A303 - Stonehenge to Berwick Down Scheme

Written Representation of:
Winterbourne Stoke Parish Council
Registration ID 20019107
&
Dr A D Shuttleworth
Registration ID 20018263

Figure 1: Map of Winterbourne Stoke with associated keypoints (blue) and Wiltshire Council byway numbers (red)

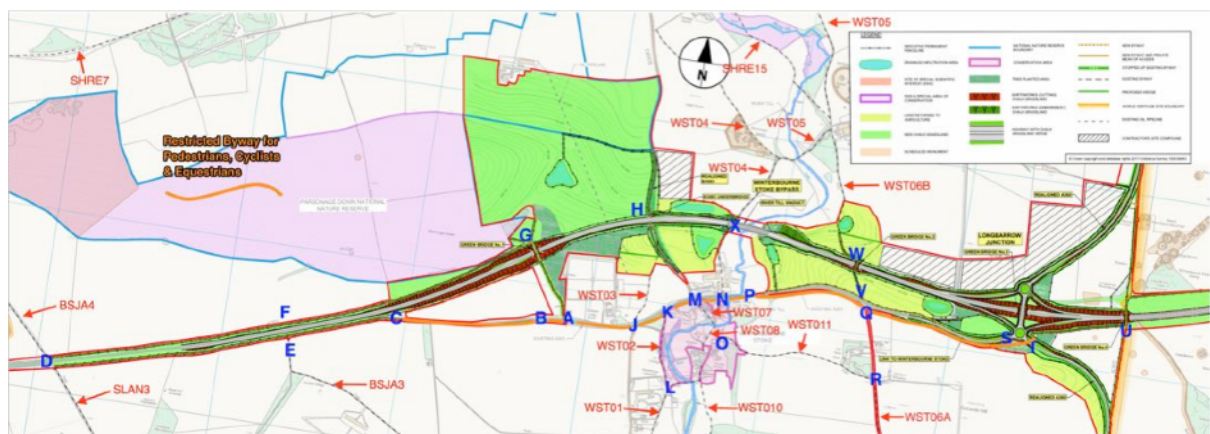
1.10 Given all the above, the western end of the scheme should be moved to the west of the Yarnbury Crossing at point D in Figure 1. To minimise these legitimate safety concerns, an underpass of the A303 should be provided (a bridge would not be appropriate at this point due to the archaeology). Entry/exits onto the A303 from SLAN3 and BSJA4 should be removed for the same reason and the gap in the central reservation could be stopped-up, enhancing traffic safety on the A303.

1.11 A safe crossing at point D is critical in joining byway networks to the north that run towards Wales and to Grovelly Wood and the Kings Way to the south - which connect byway networks westward to Dorset and Devon.

Figure 4: Map of Winterbourne Stoke with associated key points (blue) and Wiltshire Council byway numbers (red)

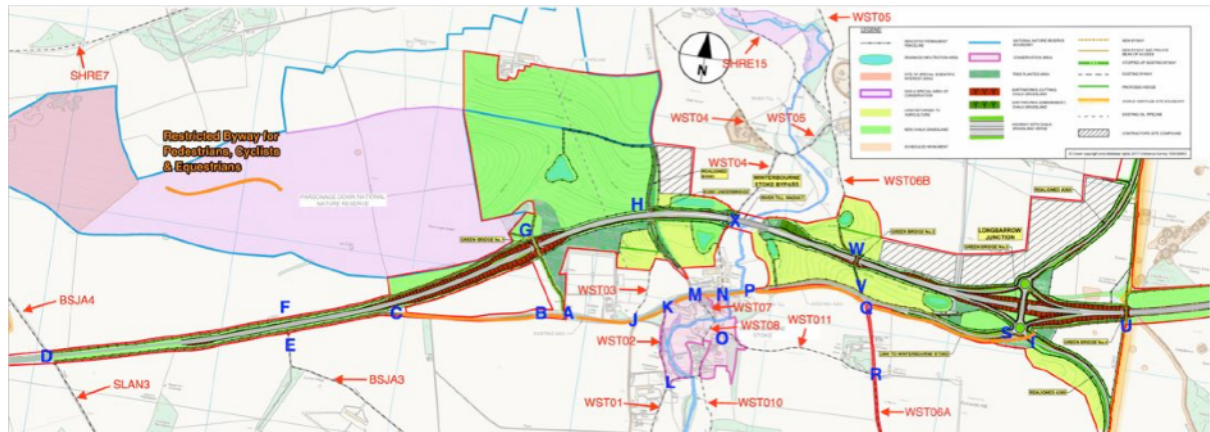
2.17 The needs of agricultural access could be better met by providing an access from the B3083, north of the A303. So, access to fields at G in Fig. 4 above, instead of being via Green Bridge 1 (A-G), should be from the northern side of the B3083, westwards from point H to point G.

Figure 8: Byway to the west of Winterbourne Stoke

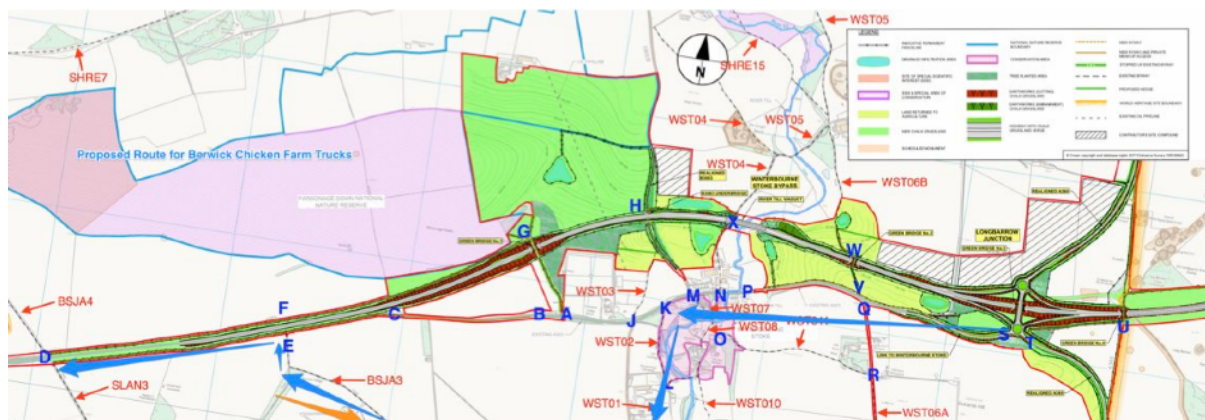
6.1 The entire route (See Fig.8 below from C via AJ-K-M-N-P-Q to S, should be suitable for pedestrians, cyclists and equestrians. From point A eastwards towards S, pedestrians, cyclists and equestrians would, ideally, need to be separated from vehicular traffic. From point P eastwards, the route for pedestrians, cyclists and equestrians should be on the southern side of the current A303, rather than the northern side as proposed by HE. Most of the village lies to the south of the A303 and so placing a pedestrian route on the northern side is simply perverse and illogical when considering likely users and usage.

6.2 The southern side of the existing A303 is preferable, as it already has wider grass verges than the northern side for much of its length. Elsewhere, the southern side consists of rough scrub, hedgerow and land of low farming value. All the land to the north of the A303 on the
